From: James Neave [REDACTED]
Sent: 21 March 2014 13:35
To: Peter Cleveland
Subject: RE: WSCC/096/13/F - Ford Waste Treatment Facility - Further Information
Attachments: The Flying Fortress rep obj received 20 Mar 14.pdf; Further info - Appendix 4 (Highways).pdf; Further info - 5. Drawing DG_ES_FOR_R23_02 (Flying Fortress fencing).pdf; 11 09 03.pdf; IMG_1105.JPG; IMG_1106.JPG

Subject: WSCC/096/13/F - Ford Waste Treatment Facility - Further Information

Project: TE1093 Circular Technology Park, Ford Airfield
Date: 26th February 2014
Author: R Spriggs

Title: Response to Highway Comments

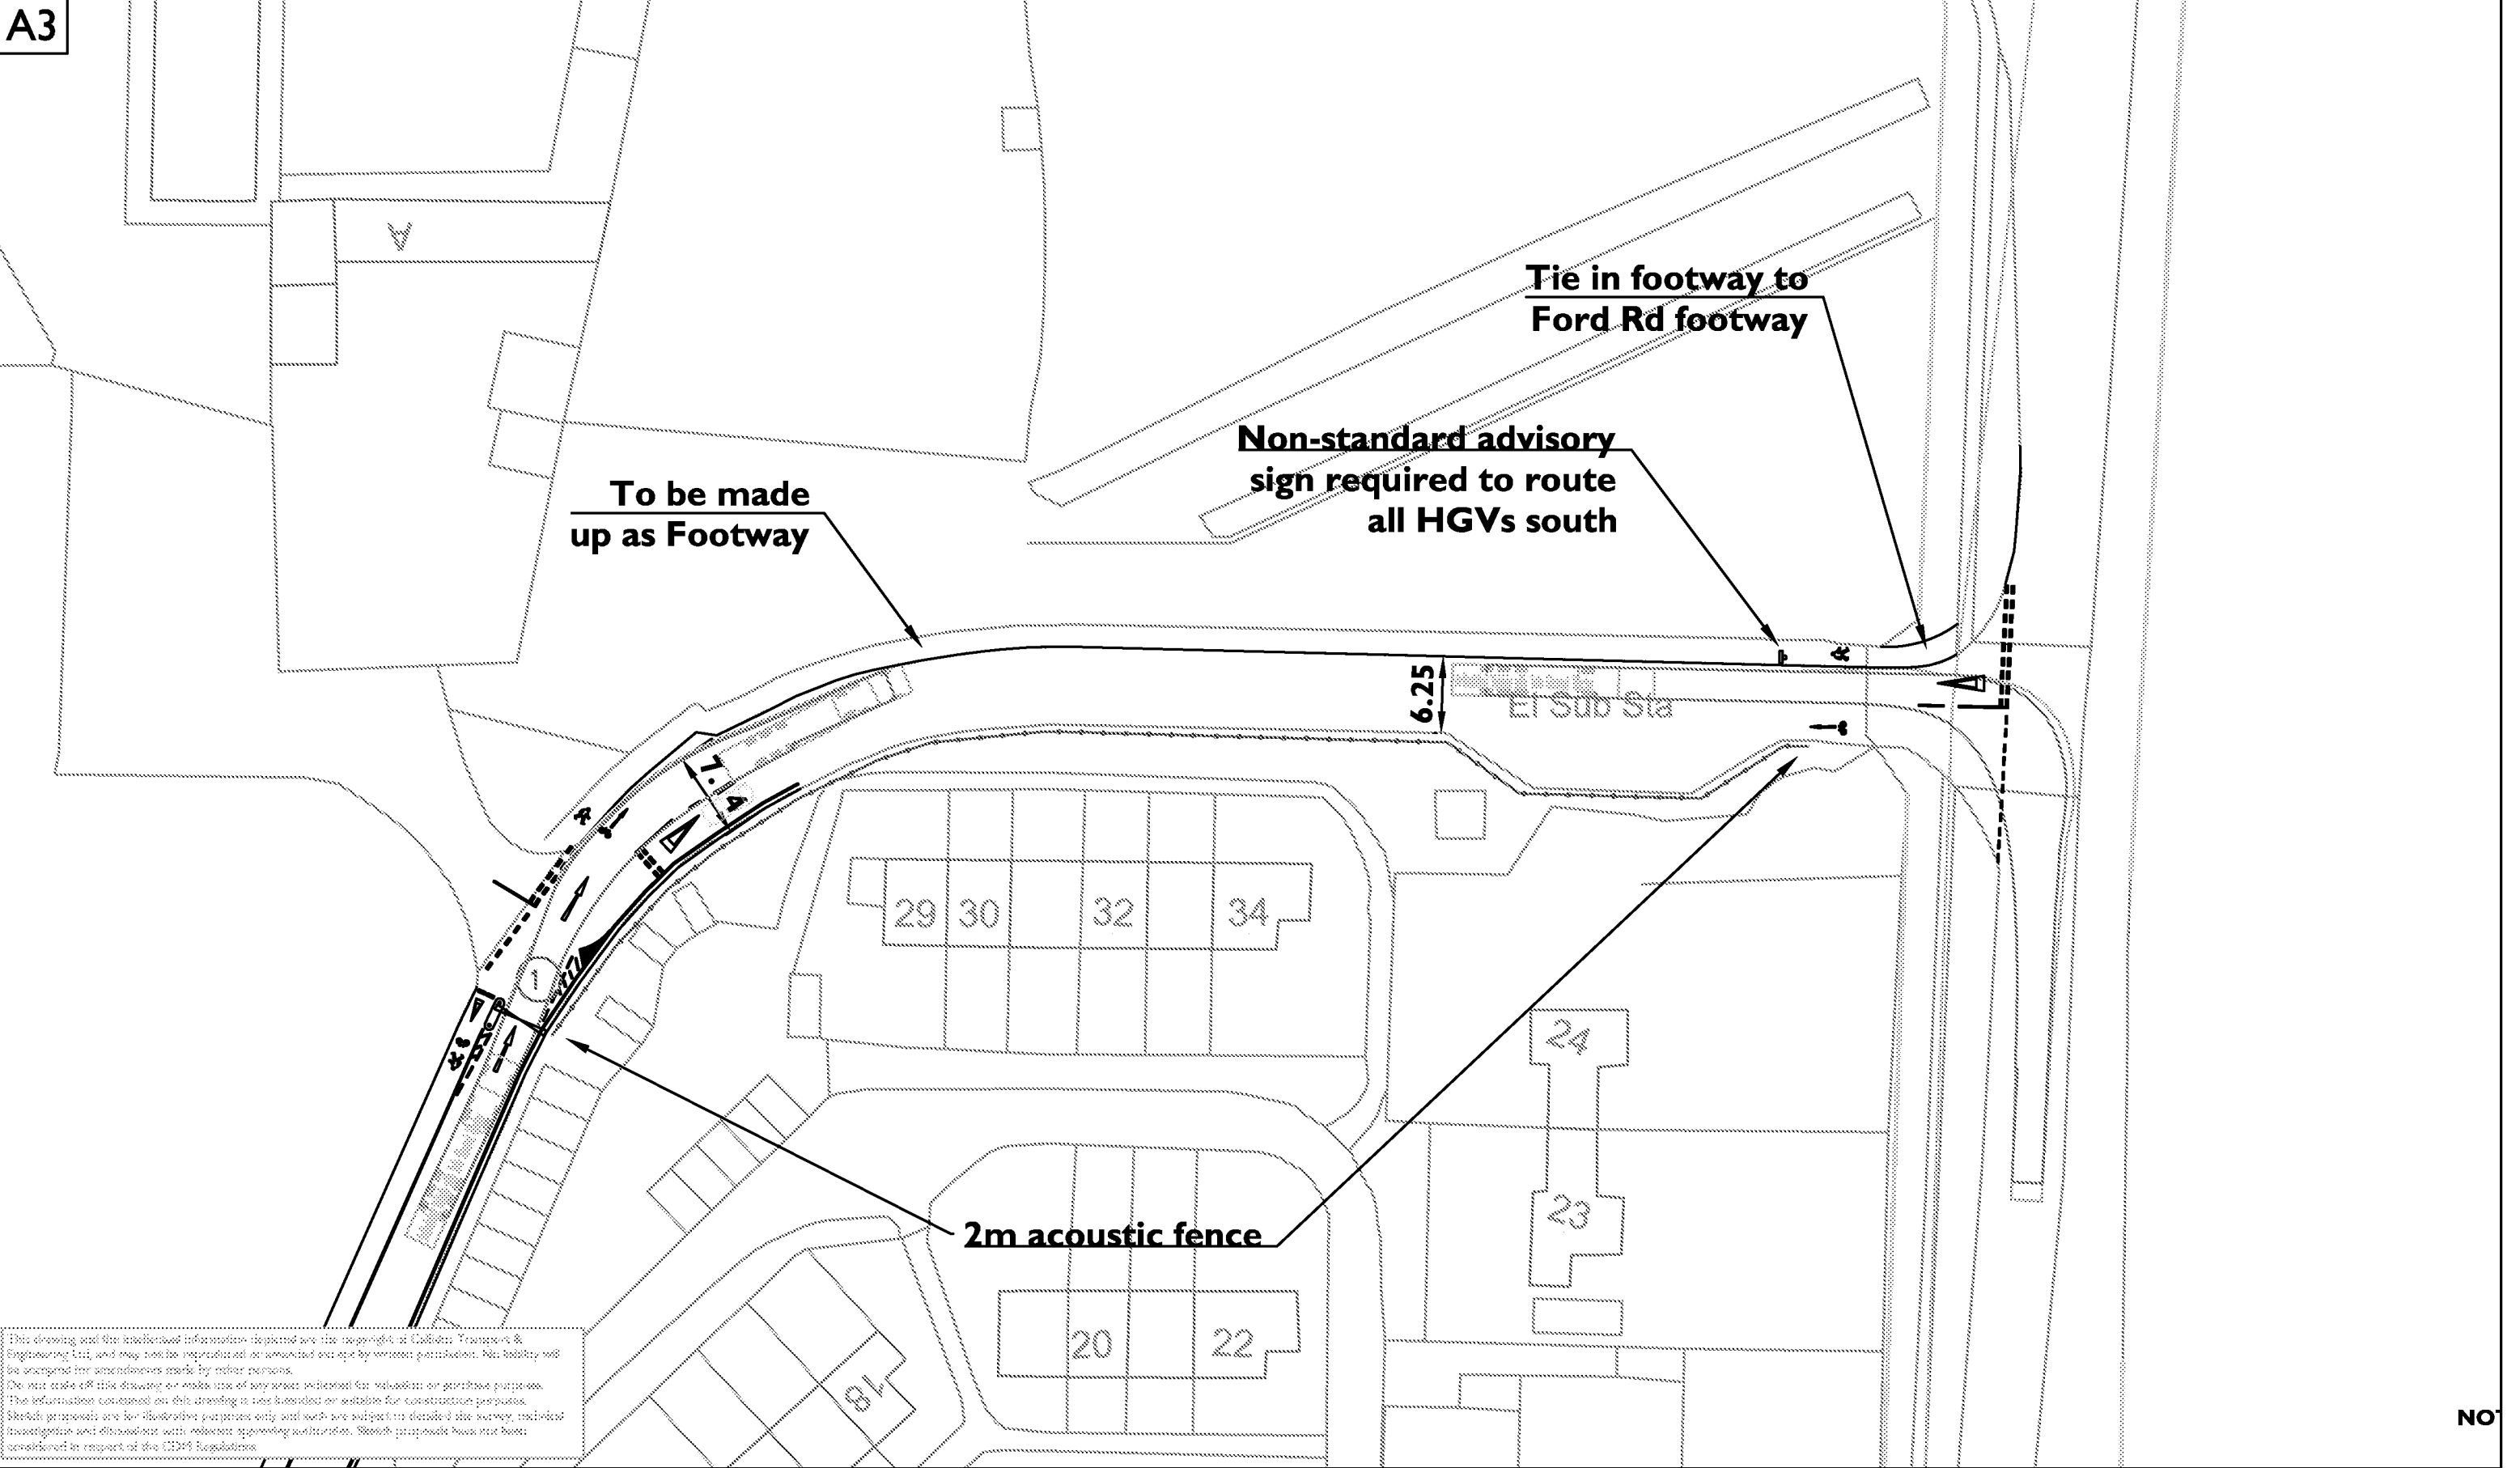
14. The section of the access road between the Mill Studio and Ford Road is shown in more detail in drawing TE1093/309. This shows how a new section of footway will be provided along the north side of the access road and tied in with the footway on Ford Road. Over this two-way section of the access road, cyclists will share the carriageway with vehicles. In addition, the drawing also shows the provision of an acoustic fence (see Figure 1 for examples of an acoustic fence) which will provide noise attenuation for properties in Rodney Crescent.

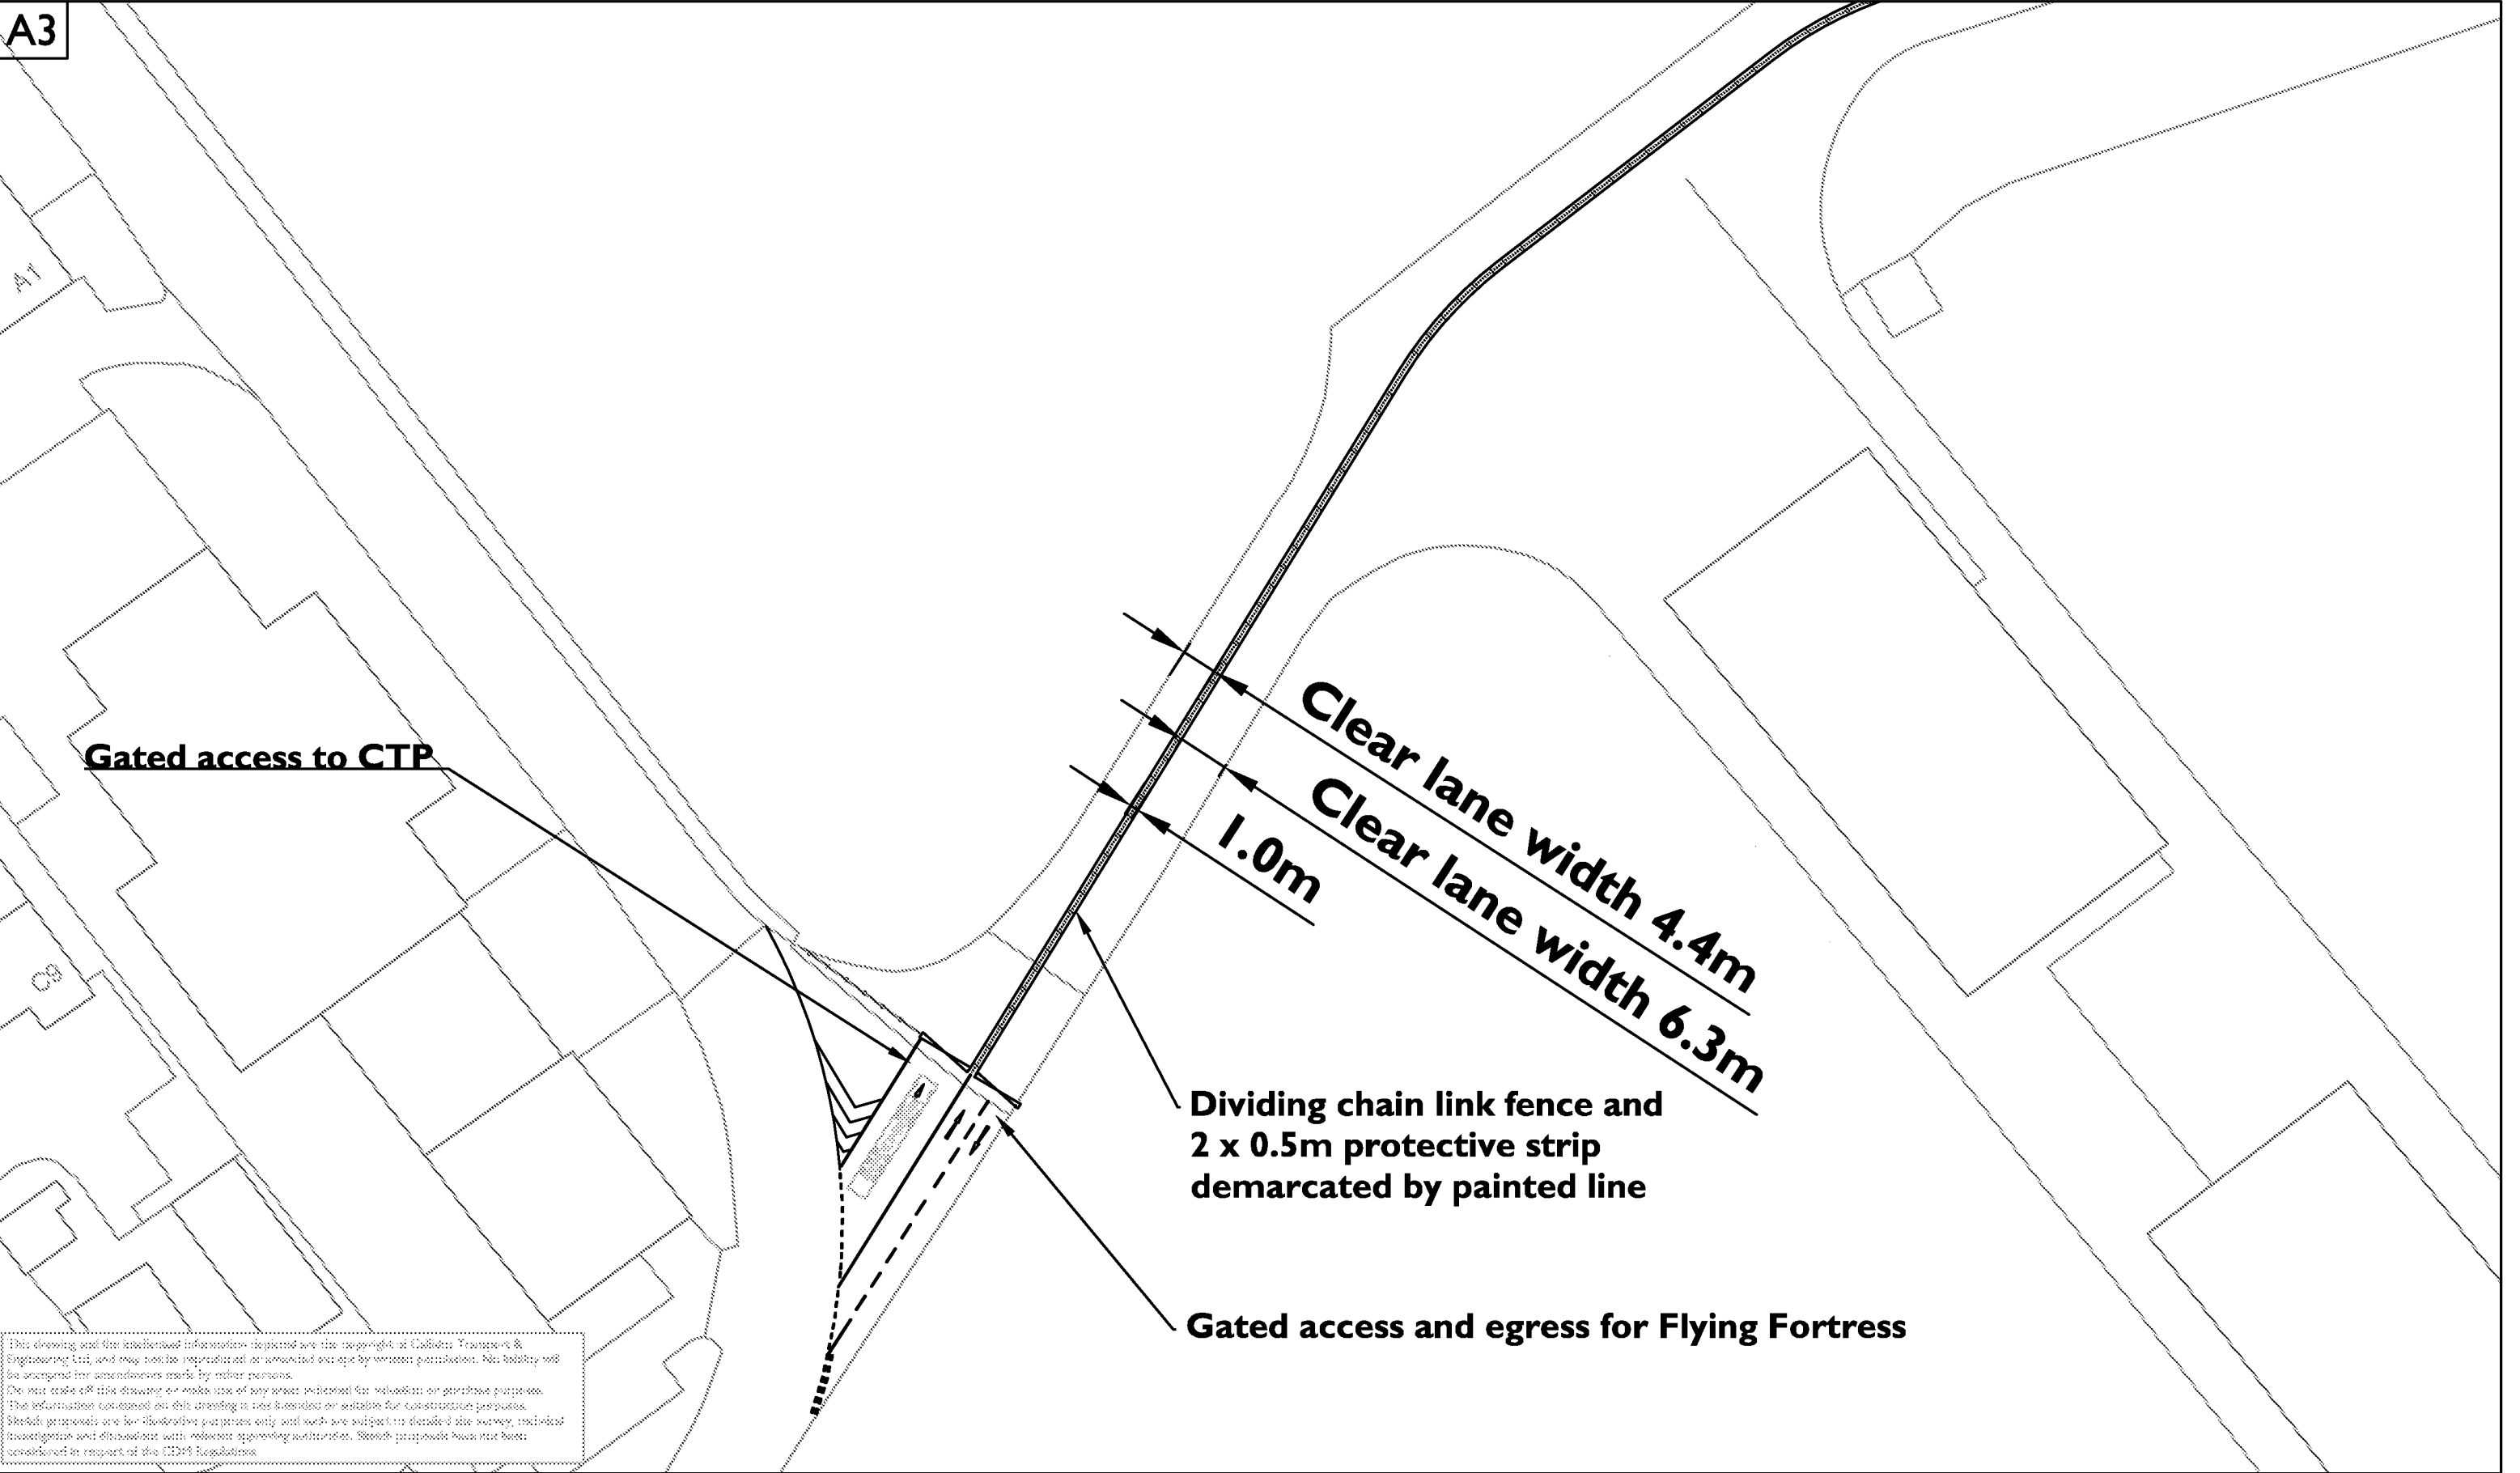
8. Whilst the applicant has a right of access over the road (former airport apron) to the north of the Flying Fortress activity centre, the applicant recognises the need to manage the potentially conflicting traffic appropriately. As part of the planning consent for the Flying Fortress activity centre, a fence was proposed that would provide a partition between the vehicles to the Flying Fortress and the trucks to the former tarmac top block site (see drawing I0353/021 by David Bennett Architects attached). This arrangement should be implemented to address the concerns raised by the Highway Authority.

9. Drawing TE1093/310 shows how the dividing fence and respective access arrangements for the site and for the Flying Fortress will function.
10. In terms of the road surface, the applicant has agreed to undertake, or pay a contribution, to resurface the unadopted part of Rollaston Park that is currently surfaced with concrete (see drawing TE1093/311). This will raise the unadopted road surface level so that it is flush with adopted road surface at either end.
